# Lafayette, CA Pipeline Tree Review

**Pacific Gas and Electric**

CN Utility Consulting, Inc.  
5930 Grand Ave  
West Des Moines, IA 50266

**September 14, 2023**

**Figure 3.** PG&E’s pipe safety zone and border zone (Figure 1 from PG&E 2017). The figure depicts the classic pipe zone border zone approach.

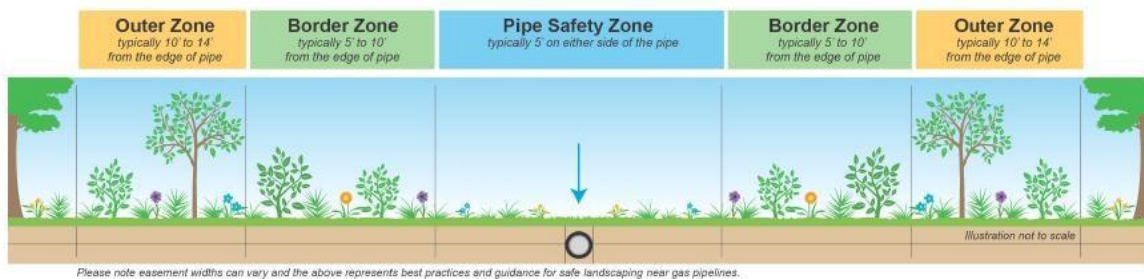
The PG&E pipeline encroachment standard specifies the classic “pipe-border zone” model (Figure 3). The pipe zone is managed as a treeless area to prevent roots from interfering with pipelines, maintain access for maintenance, and identify the pipeline location in the right-of-way. This approach is compatible with accepted vegetation management practices, which advise that the width of the treeless zone should be determined by the operator (Miller, 2021; Miller and Kempter, 2018).

The PG&E approach is based on the observation listed in #9 in the *Field Study by Randall Frizzell & Associates and Dynamic Risk* section (above) that the distance to the buried pipe and its depth below the ground are crucial in determining whether trees are likely to interfere with and potentially compromise underground pipelines. PG&E's process is detailed in their *Utility Procedure: TD-4490P-03* (PG&E, 2017a). Dynamic Risk (2015) recommended applying the Pythagorean theorem to determine a "z factor" in identifying trees for removal. The "z-factor" is the hypotenuse of a right triangle formed with the horizontal distance of a tree to the point on the soil surface directly above a pipe on one leg, and the distance from the soil surface down to the depth of the pipe on another. Dynamic Risk observed that where the hypotenuse between the tree and pipe was less than 5- feet, coating damage occurred in over 90% of the observations in their study, and where it was between 5- and 10- feet, it was observed in two-thirds of the cases.

The PG&E screening tool seems reasonable to CNUC considering the Randall Frizzell & Associates-Dynamic Risk study. The protocol calls for classifying trees into those with a mature diameter at breast height (DBH) of 17- inches or less and those more than 17- inches. Using this technique, trees less than 17- inches in DBH at maturity will be removed if the "z-factor" is 3.6- feet or less (e.g., trees less than two feet horizontally from the pipe that is 3- feet or less underground). For larger trees at maturity, trees with a "z-factor" of 5.3- feet or less (i.e., trees less than two feet from a pipe that is 5- feet or less below ground) will be removed. CNUC considers this to be a reasonable approach, given that pipe coating damage was observed in over 90% of cases where the "z-factor" was 5- or fewer feet.
